Access Compliance Report Public Rights-of-Way (Curb Ramps)

Main Street: ACECA_DR Cross Street: NORGROVE_LN Location: NW

ADA ID: RPRK211216132457 Ramp Type: Type 1 - Perpendicular Diagonal Initial Pass/Fail: Pass Overall Compliance: No Severity Score: 12

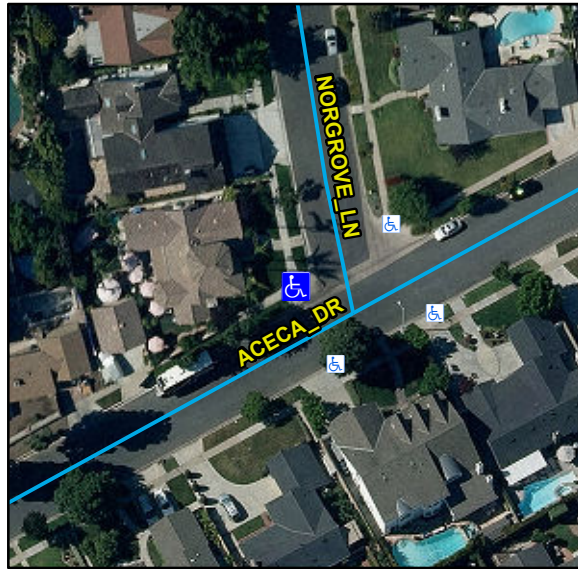
Compliance	Description	Data	Compliance	Description	Data
N/A	Ramp Length (in)	81	N/A	Flare Type LT	
Yes	Ramp Width (in)	48			Sloped
Yes	Ramp Run Slope (%)	8	N/A	Flare Slope LT (%)	4.7
Yes	Ramp Cross Slope (%)	1.3	N/A	Flare Traversable LT	No
N/A	Landing Present	Yes	N/A	Flare Type RT	
N/A	Landing Length (in)	49			Sloped
Yes	Landing Width (in)	48	N/A	Flare Slope RT (%)	5.5
No	Landing Run Slope (%)	2.2	N/A	Flare Traversable RT	No
Yes	Landing Cross Slope (%)	1.6	No	DWS Provided	No
N/A	Landing Movement Obstructed?	No	N/A	DWS Contrast	N/A
	Landing Movement Type	N/A	N/A	DWS Length (in)	N/A
N/A	Landing Shared	No	N/A	DWS Full Width	N/A
N/A	Clear Space	Yes	N/A	DWS Offset Left (in)	N/A
N/A	Clear Space To Crosswalk (in)	48	N/A	DWS Offset Right (in)	N/A
N/A	Marked Crosswalk 1	No	N/A	Marked Crosswalk 2	No
	Crossing 1 Direction	S		Crossing 2 Direction	E
	Marked Crosswalk 1 Width (in)	N/A		Marked Crosswalk 2 Width (in)	N/A

N/A	Ramp Inside Crosswalk 1	N/A	Yes	Ramp Inside Crosswalk 2	N/A
	Crossing 1 Slope (%)	6.8		Crossing 2 Slope (%)	1.2
	Crossing 1 Cross Slope (%)	0.2		Crossing 2 Cross Slope (%)	3.2
No	Gutter Ponding	Yes	Yes	Curb Slope	3.4
No	Gutter Lip Height (in)	0.25		Road Run Slope (%)	0.8
Yes	Gutter Run Slope (%)	0.2		Road Cross Slope (%)	2
Yes	Gutter Cross Slope (%)	0.8			
Yes	Overall Surface Condition: Acceptable		No	Perp Joint Present	No
	Cross Gutter Present?	Yes		Spandrel Present?	Yes
	Replace Cross Gutter?	No		Replace Spandrel?	No

Remove & Replace Curb Ramp With Two New Directional Ramps or Equivalent. Grind Gutter Lip.
